STAFF REPORT
COMMUNITY DEVELOPMENT DEPARTMENT

HEARING 4/27/2020
DATE:
TO: Mayor & City Council
FROM: Alan Tiefenbach, Associate Planner
208-884-5533
Bruce Freckleton, Development
Services Manager
208-887-2211
SUBJECT: MFP-2021-0004
Lupine Cove - MFP
LOCATION: 4000 N. McDermott Rd., in the NW ¼ of
Section 33, Township 4N., Range 1W.

Modification to the final plat for Lupine Cove to shift northern stub street (N. Patmos Ave) approximately 50 feet to the east.

B. Modified Final Plat for Lupine Cove Subdivision – MFP-2021-0004 (date: 4/5/2020)

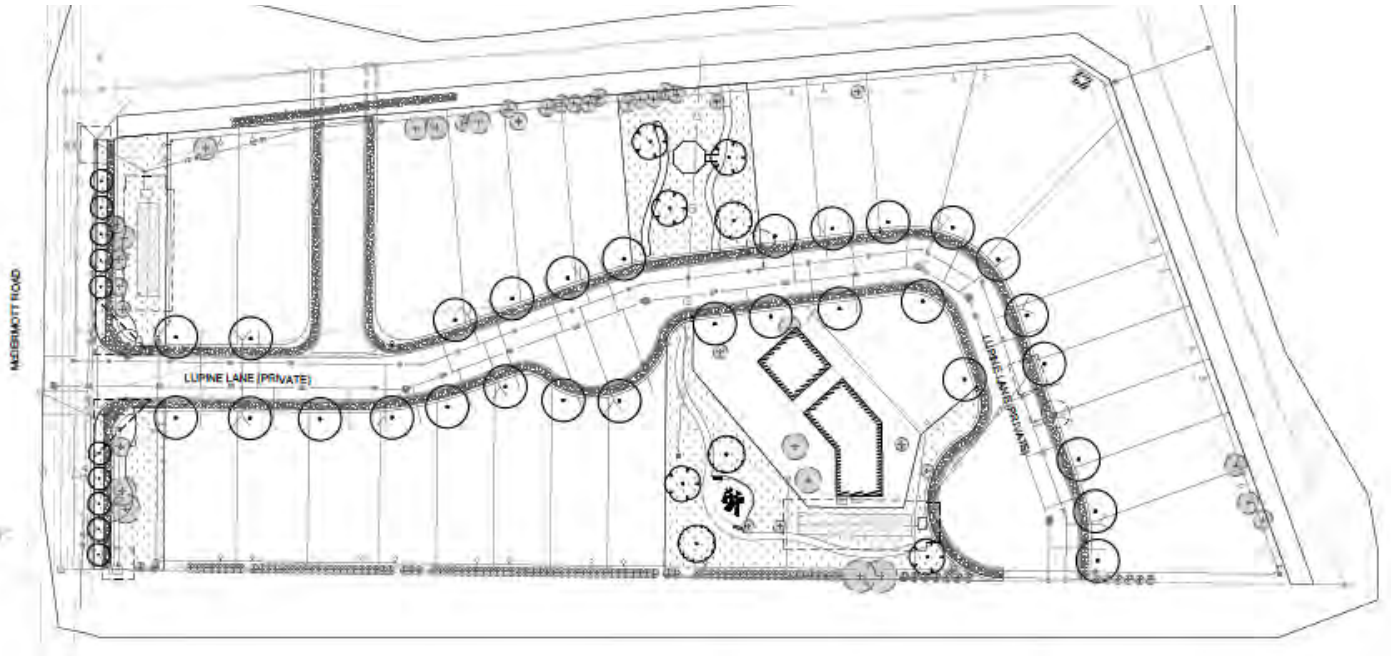
This is a request for a modification to the final plat of Lupine Cove to shift the northern stub street (N. Patmos Ave) approximately 50 feet to the east. This final plat for 26 buildable lots and 6 common lots on 6.89 acres of land in the R-8 zoning district was approved by the City Council on February 9, 2021. Following the City Council meeting, ACHD requested for N. Patmos Ave to be shifted to the east to align with a stub street from the Aegean Subdivision to the north and increase the offset to McDermott Rd.
